4 Project changes and design refinements

The EIS for the project was prepared based on a concept project design (refer Chapter 5 of the EIS). This design has since been refined to account for design changes and in response to submissions received during exhibition of the EIS.

The Northern Road upgrade -
Mersey Road to Glenmore Parkway
**Construction Boundary and
Compound Sites**

Figure 4-1 | Overview of design refinements for the project

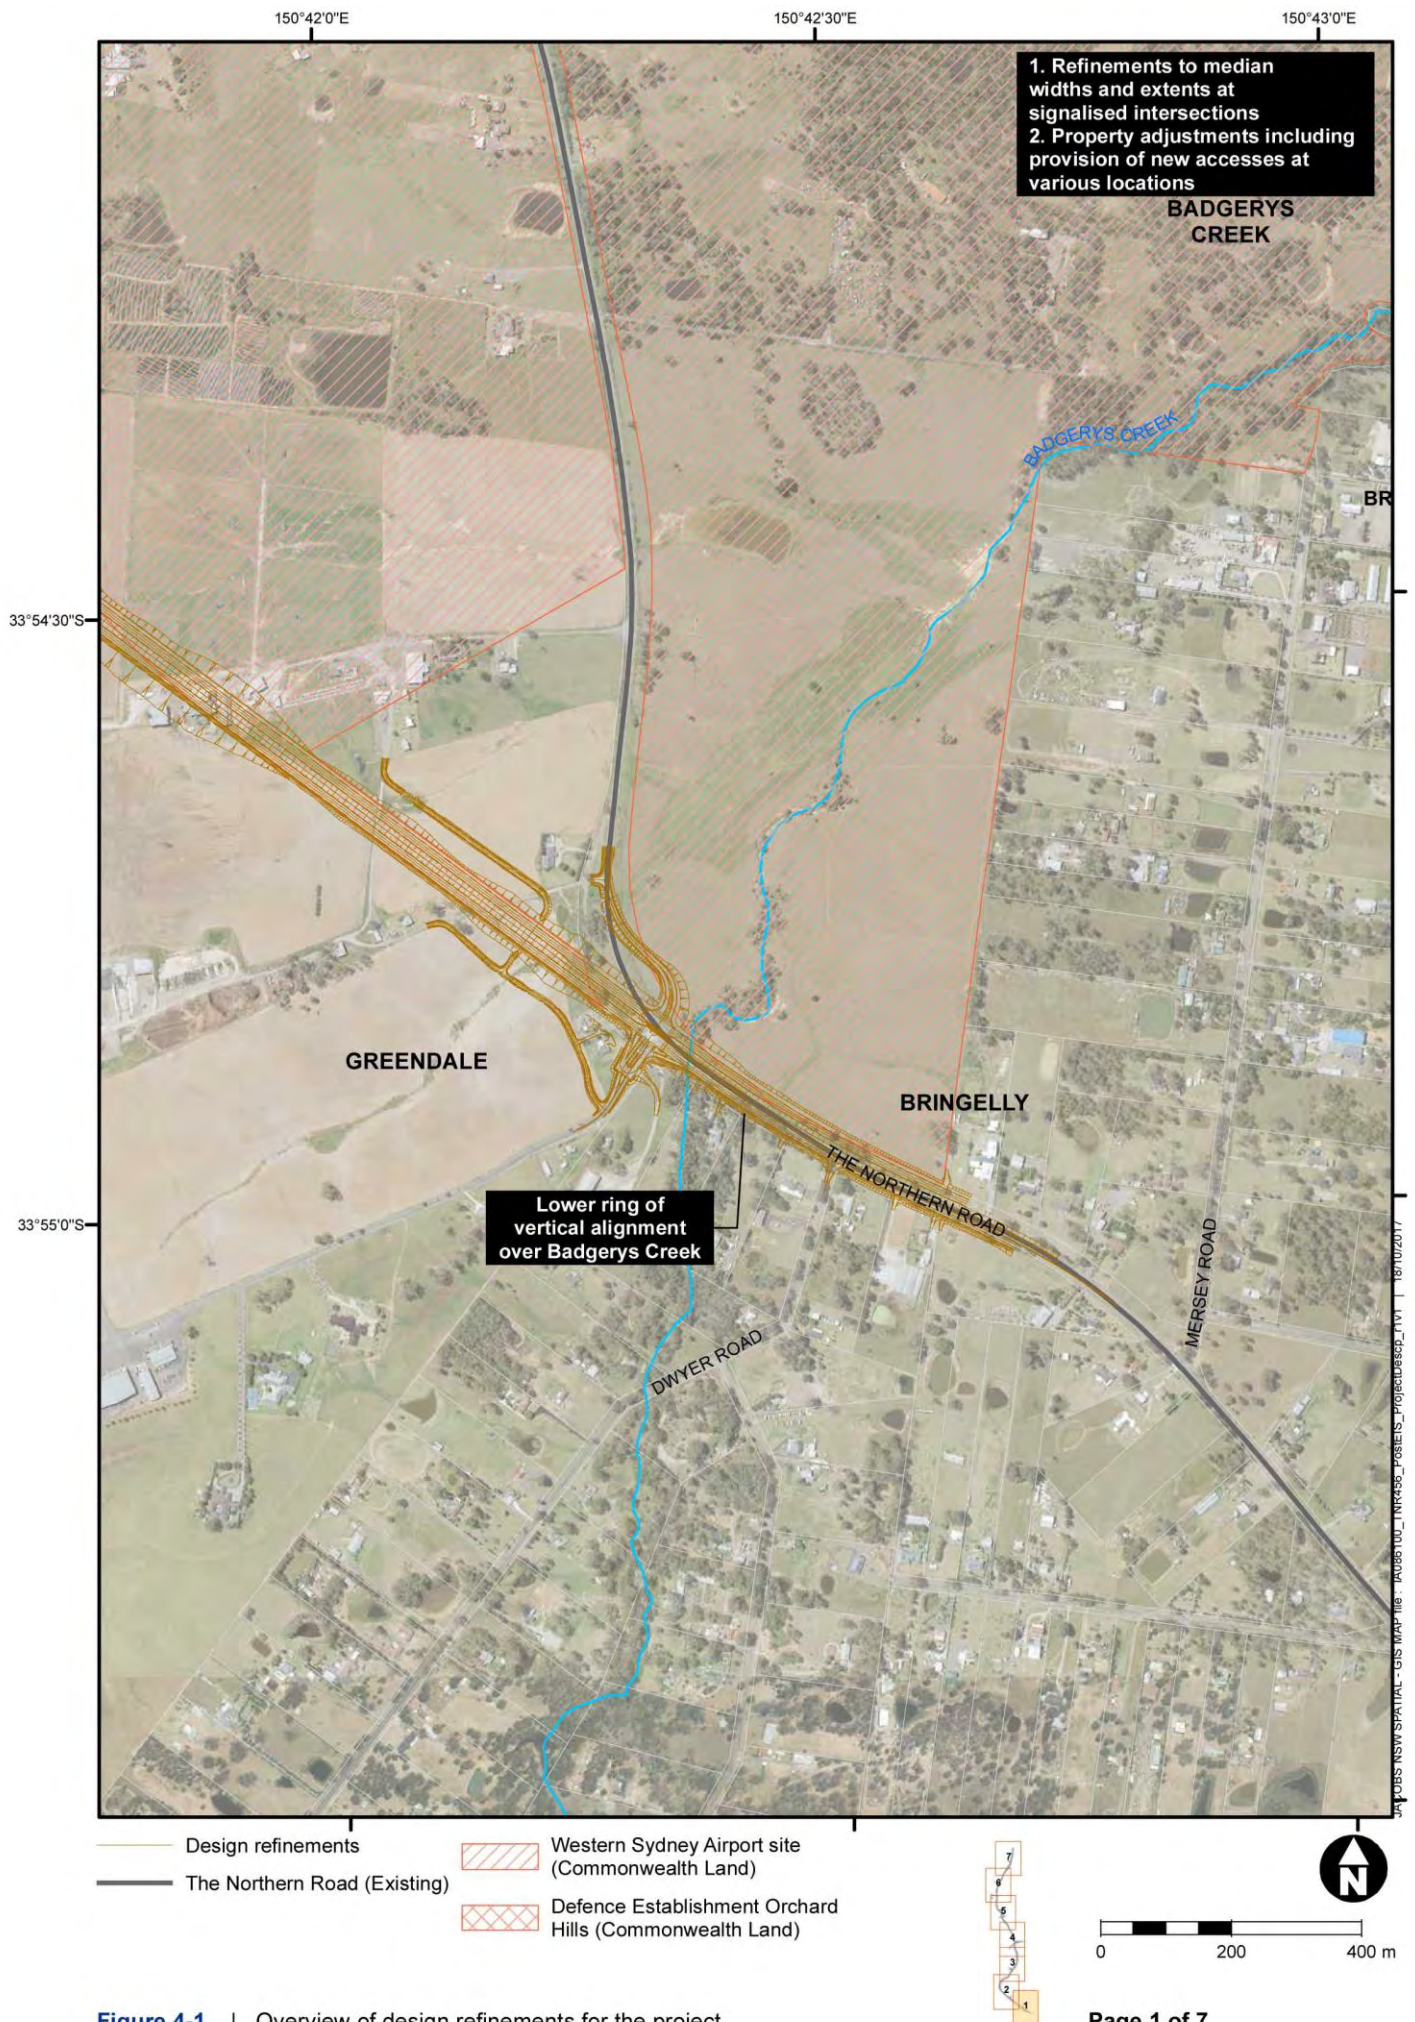
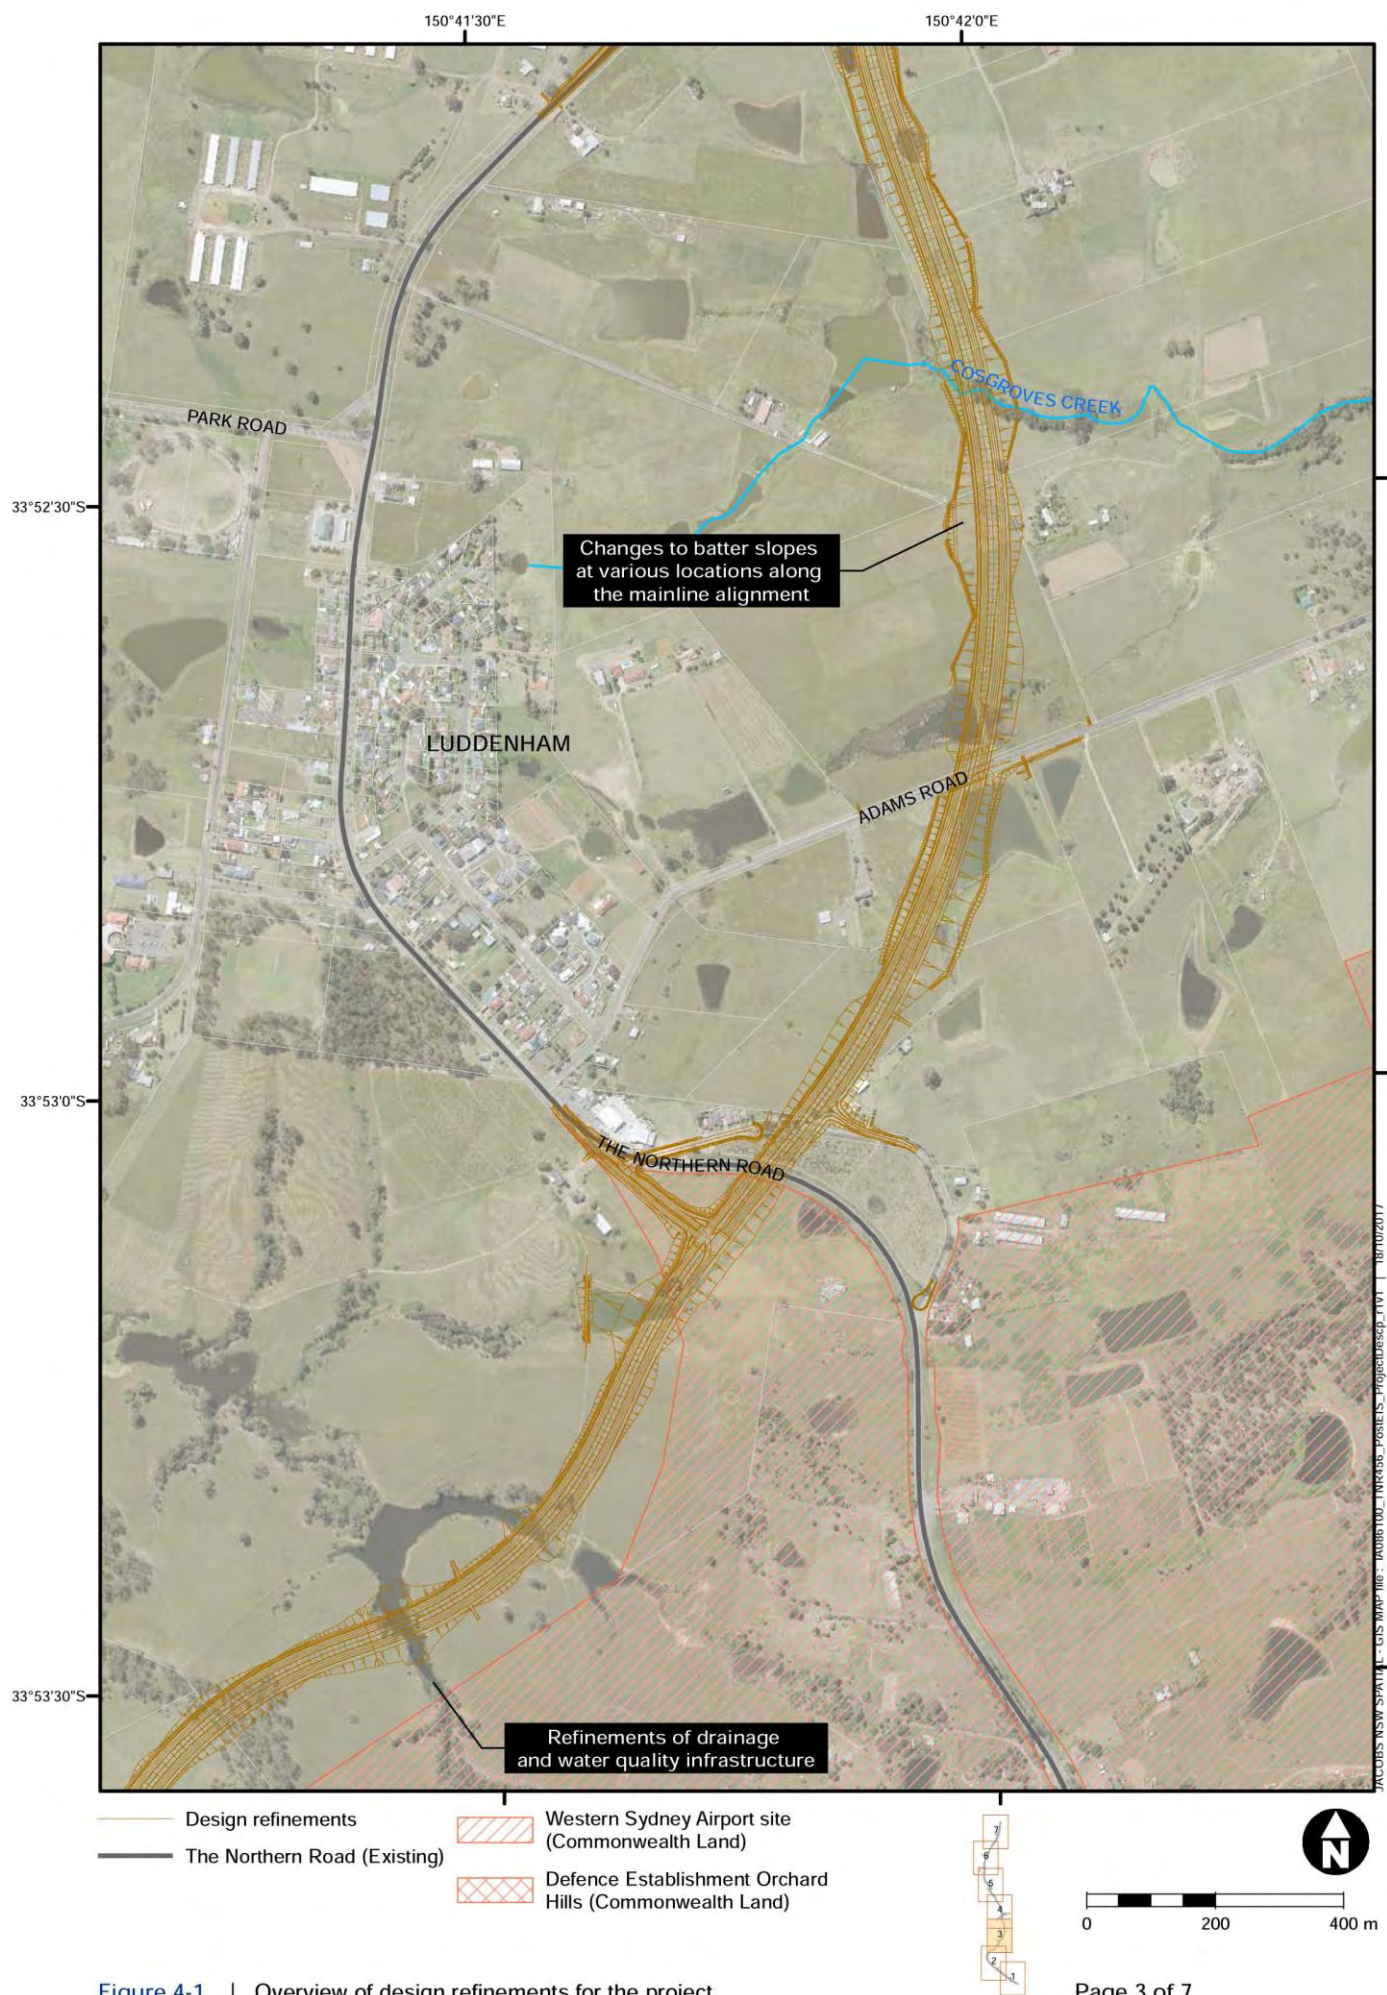
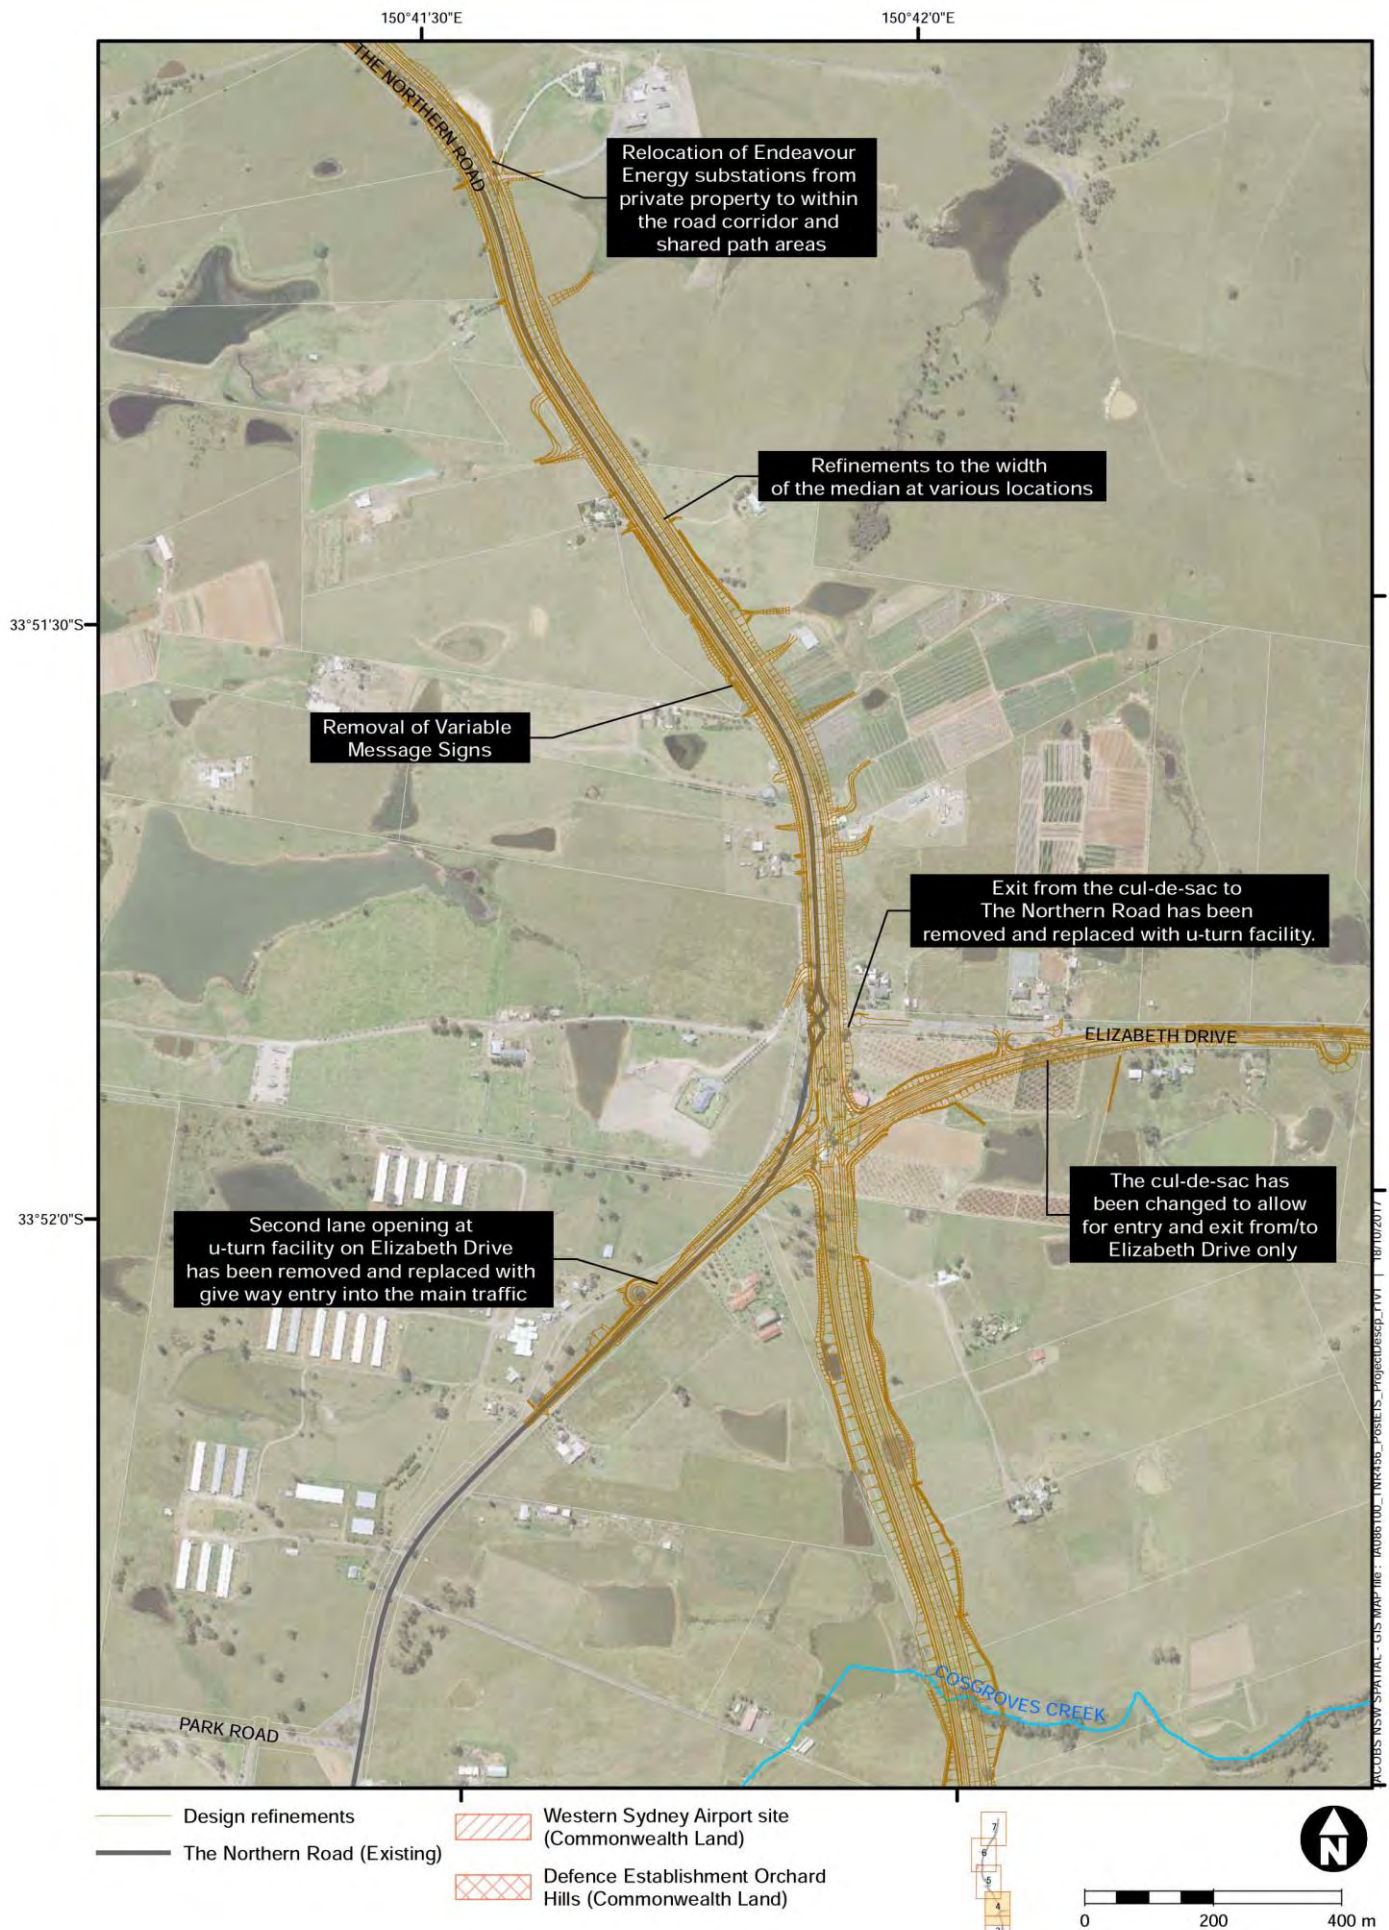
An overview of the design refinements for the project is provided in Table 4-1. This includes details of the justification for the change and any further environmental assessment undertaken since exhibition of the EIS in order to assess the change. Figure 4-2 provides an overview of the key design refinements.

Design refinement / location	Justification for refinement	Further assessment provided	Where addressed in this report
Changes to staging and delivery			
Bus lanes converted from continuous lanes along the main alignment to priority lanes at intersections only at opening with provision for continuous lanes in the future as demand requires.	The project will include bus priority at intersections for project opening. There is currently not the bus frequency along The Northern Road to warrant a dedicated bus lane. Further consideration of timing for the implementation of bus lanes between intersections will be undertaken in conjunction with the TfNSW as they develop and implement the new regional bus network to support the Western Sydney Airport and Priority Growth areas.	Changes to the staging and delivery of the project have not resulted in an increase to the construction or operational footprint of the project. The changes have been considered with regards to traffic and transport assessment.	Section 5.1.1

Design refinement / location	Justification for refinement	Further assessment provided	Where addressed in this report
Cuttings, embankments and median			
Changes to batter slopes at various locations along the alignment.	Steepening of some batters to a maximum of 1:2 slope has occurred to minimise property impacts particularly on DEOH land. Some batters have been steepened to avoid existing utilities such as water mains.	Refinements to batters and medians have not resulted in an increase to the construction or operational footprint of the project. Changes to the end height of batter slopes has been considered as part of the revised noise and vibration and hydrology and flooding assessments.	Section 5.1.2 and Appendix B Section 5.2.1
Provision of a section of split carriage way for a short section between Gates Road and Longview Road.	To reduce batter impact to properties and improve driveway access gradients on the western side of the alignment.	Splitting of the carriageway and change to elevation of the road has been considered as part of the revised noise and vibration and hydrology and flooding assessments.	Section 5.1.2 and Appendix B Section 5.2.1

Design refinement / location	Justification for refinement	Further assessment provided	Where addressed in this report
Utilities and services			
Relocation of Endeavour Energy substation from private property to within the road corridor and shared path areas.	Adjustments have been made to reduce property impacts on the western side of the road corridor.	Refinement has resulted in a reduction of impacts beyond the road corridor and as such no further assessment has been carried out. Refinements have been made in consultation with utility providers.	Response to Submission in Chapter 3.
Design criteria (geometry and alignment)			
Superelevation adjustments, changes to the radius of vertical curves and refinements to longitudinal grading at various locations along the alignment.	Compliant super elevations to reduce aquaplaning at several locations. Curve radius generally increased to achieve the required approach sight distance. Grading adjustments to generally improve stormwater drainage management and reduce aquaplaning.	Superelevation adjustments and changes to vertical alignments in some locations have resulted in changes to the height of the road pavement. Where this has occurred it has been considered as part of the revised noise and vibration and hydrology and flooding assessments.	Section 5.1.2 and Appendix B Section 5.2.1

Design refinement / location	Justification for refinement	Further assessment provided	Where addressed in this report
Local road changes and upgrades			
Refinement of Vineyard Road extension.	Road has been realigned to reduce property impacts and avoid the 750 mm watermain.	Refinement of Vineyard Road extension has been considered in all revised assessments related to changes in footprints such as Biodiversity, Non-Aboriginal and Aboriginal Heritage.	Chapter 5 Appendix C Appendix D
Adjustment to the alignment of the roundabout at Kings Hill Road and Vineyard Road.	To avoid existing water main fittings.	Although a minor refinement, additional biodiversity survey at Kings Hill Road has been carried out.	Appendix C
Gates Link Road alignment realigned further to the east.	Realignment to ensure resident can maintain access to property's water supply and allow for constant width between link road and The Northern Road to not preclude future land use. Refinements have also been made to fit with the proposed drainage strategy and reduce earthworks.	Refinement of Gates Link Road has been considered in all revised assessments related to changes in footprints such as Biodiversity, Non-Aboriginal and Aboriginal Heritage.	Chapter 5 Appendix C Appendix D

Design refinement / location	Justification for refinement	Further assessment provided	Where addressed in this report
The cul-de-sac at Elizabeth Drive has been reconfigured to allow for entry and exit from/to Elizabeth Drive only. Exit from the cul-de-sac to The Northern Road has been removed and replaced with u-turn facility. Second lane opening at u-turn facility on Elizabeth Drive (west of intersection with Northern Road) has been removed and replaced with give way entry into the main traffic.	The left turn onto The Northern Road from the existing Elizabeth Drive was removed due to concerns about the proximity to signalised intersection and traffic management and safety issues. To eliminate weaving over a short distance before the intersection.	Changes to the configuration at Elizabeth Drive have been considered with regards to traffic and transport assessment.	Section 5.1.1
Grover Crescent (north) access changed to left in, left out Grover Crescent (south) access removed.	Improved safety for vehicles entering The Northern Road from Grover Crescent	Changes to Grover Crescent have been considered with regards to traffic and transport assessment.	Section 5.1.1

Design refinement / location	Justification for refinement	Further assessment provided	Where addressed in this report
Reconfiguration of Littlefields Road intersection to have a left-straight lane and a right turn lane to allow changed signal phasing.	Reconfiguration to allow for staged pedestrian crossings and to accommodate 26m B-Double vehicles.	Changes to the turning movements at intersections have been considered as part of the additional traffic assessment	Section 5.1.1
Round-about on Littlefields Road changed to a u-turn facility.	Additional u-turn facility to accommodate large vehicle access to adjoining property, replacing previously proposed roundabout.	No further assessment required.	N/A
U-turn stub added to roundabout opposite DEOH entrance.	To allow 26 metre b-doubles to access the left lane.	Operational footprint change is within the area previously assessed as part of the EIS construction footprint. No further assessment required.	N/A

Heavy vehicle inspection bays			
Removal of northbound heavy vehicle inspection bays.	After a review of the proposed HVIS at Grover Crescent, it was determined that this site was not suitable from a road safety or operational prospective for the implementation of a HVIS. Several other locations have been identified and investigated, however each of these sites have issues with road safety, operation of the facility, property acquisition, property access and/or utilities. Further to this, there are currently unknowns in regard to the locations of the proposed M12 and Outer Sydney Orbital (M9) and how they interface with The Northern Road upgrade - which may have impacts on the locations of potential northbound HVIS.	No further assessment has been carried out as a result of removing the northbound heavy vehicle inspection bays.	Response to Submission in Chapter 3

Traffic management facilities			
Removal of Variable Message Signs (VMS) at the approaches to Elizabeth Drive and heavy vehicle inspection bays.	Further investigation determined that a VMS was not required on approach to the heavy vehicle inspection station. Space has been allowed for implementation of VMS required on the TNR southbound approach to the M12 for the future installation of a VMS.	The removal of Variable Message signs has been considered in the revised Urban Design and Visual Impact assessment	Section 5.2.5
